Duke Energy Corporation

Subject: McGuire Nuclear Station, Unit 2
Docket No. 50-370
Relief Request 01-001

RELIEF REQUEST NO. 01-001

McGuire Nuclear Station - Unit 2

Component ID/Weld No. 2RCPA - TE

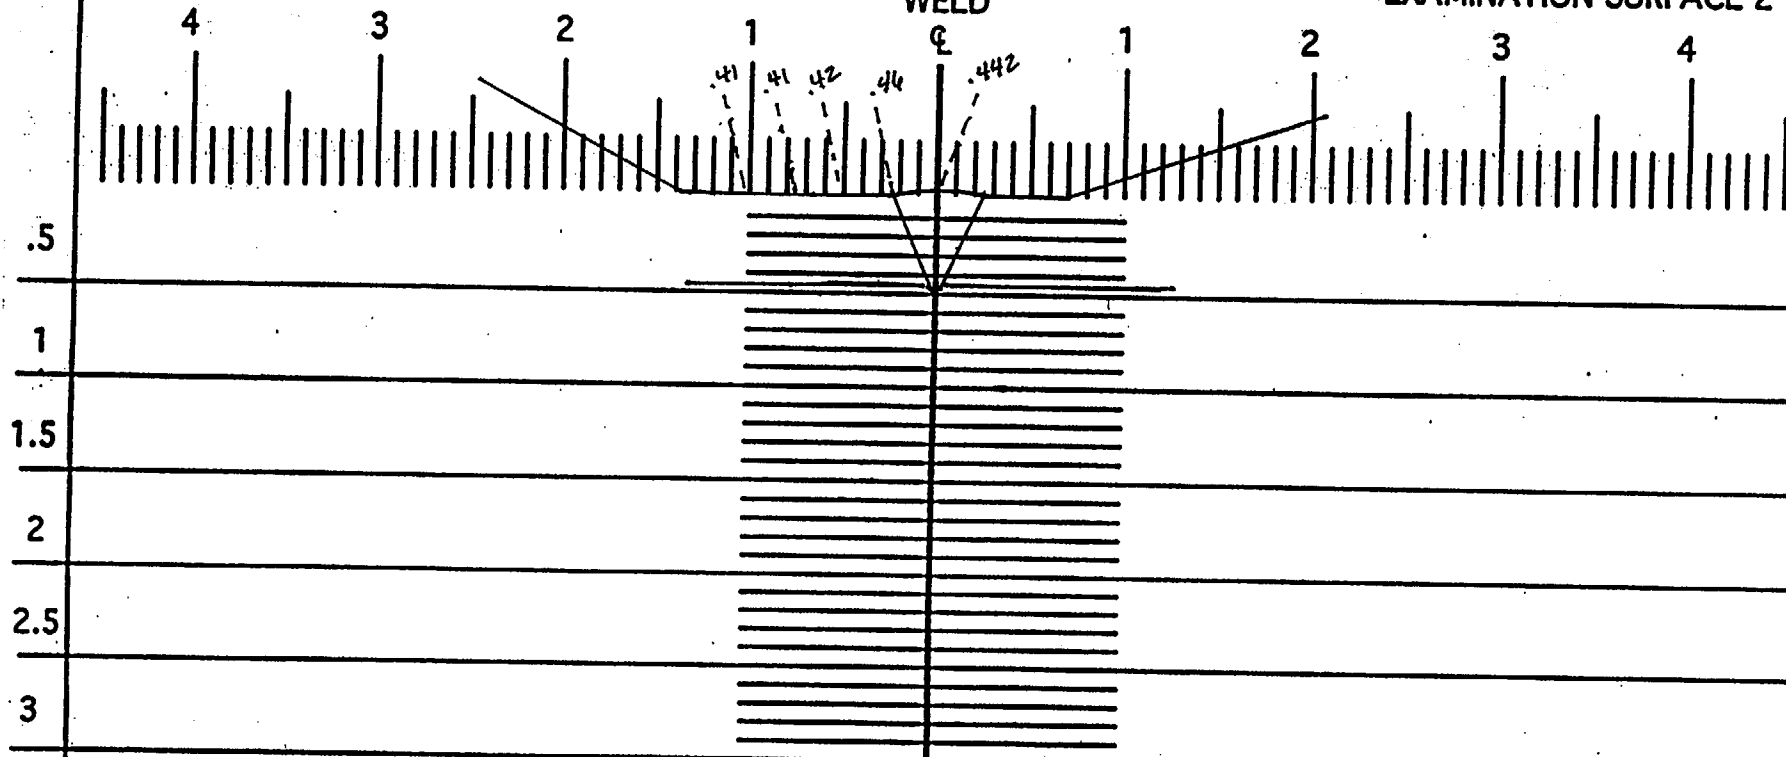
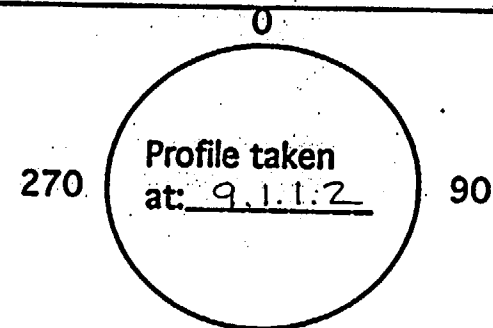
During the ultrasonic examination of the Chemical and Volume Control System Circumferential Weld 2RCPA-TE (C05.021.081) coverage of the required examination volume could not be obtained. The examination coverage was limited to 58.17%. This is a stainless valve to tee weld where access is limited to one side only. See Attachment 3.

Subject C05.021.081

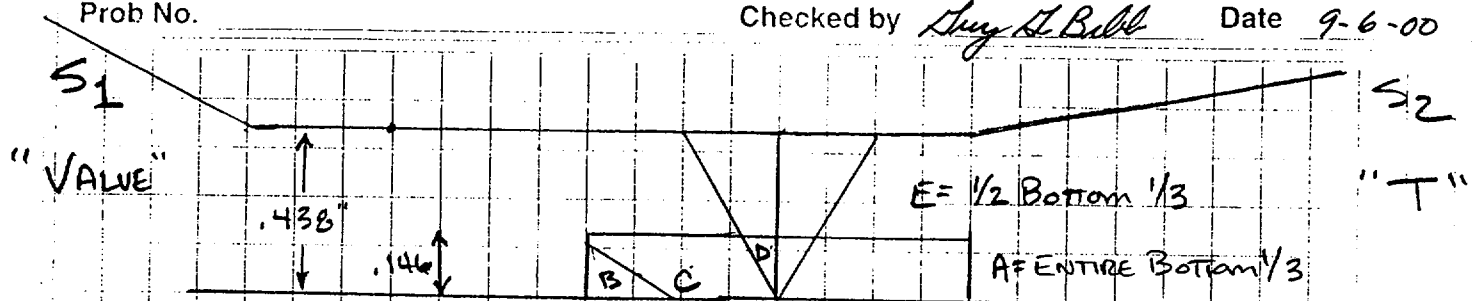
$$A = 1.0 \times .15 = .15 \text{ (TOTAL DESIRED VOLUME) or (AREA CALCULATION)}$$

$$B = \frac{.25 \times .15}{2} = .01875 \text{ (AREA NOT COVERED BY SHEARWAVE)}$$

$$C = .075 - .01875 - .0075 = .04875 \text{ (.60° SHEAR COVERAGE)}$$

$$D = \frac{.10 \times .15}{2} = .0075 + .075 = .0825 \text{ (D+E) = (AREA SHEARWAVE WONT PUNCH DO TO WELD)}$$

$$L\text{-WAVE COVERAGE} = .075 + .0075 = .0825$$
